**DRAFT** TRANS/WP.29/GRB/2002/4/Rev.1 \*/  
~~28 October 2002~~

PROPOSAL FOR DRAFT AMENDMENTS TO REGULATION No. 51

(03 series of amendments)

Transmitted by the Expert from Germany and the  
International Organization for Standardization (ISO)

Figure 1

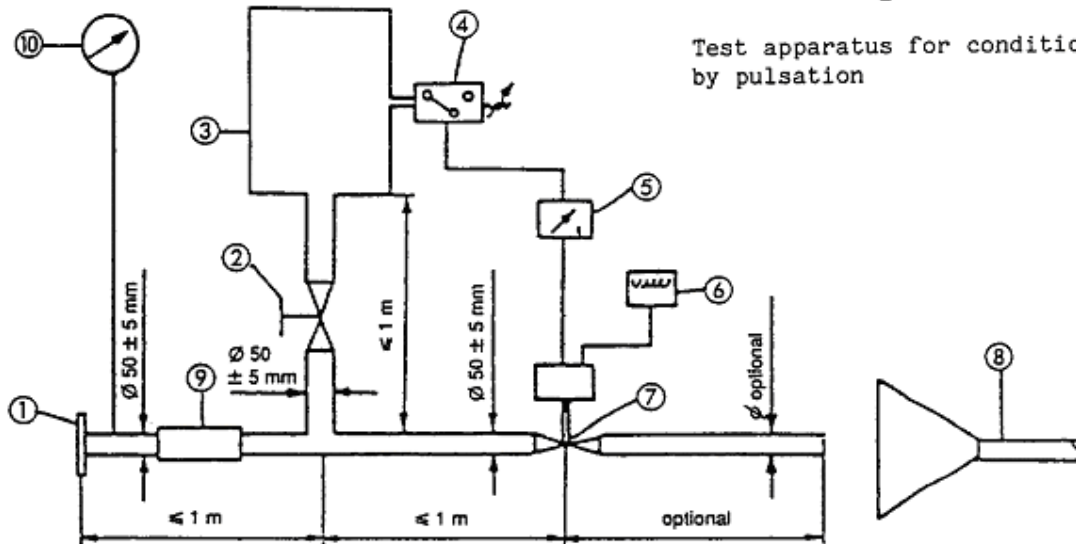
In the second case, the engine must be mounted on a dynamometer. The test apparatus, a detailed diagram of which is shown in Figure ~~3-1~~ of the appendix to this annex must be fitted at the outlet of the exhaust system. Any other apparatus providing equivalent results is acceptable.
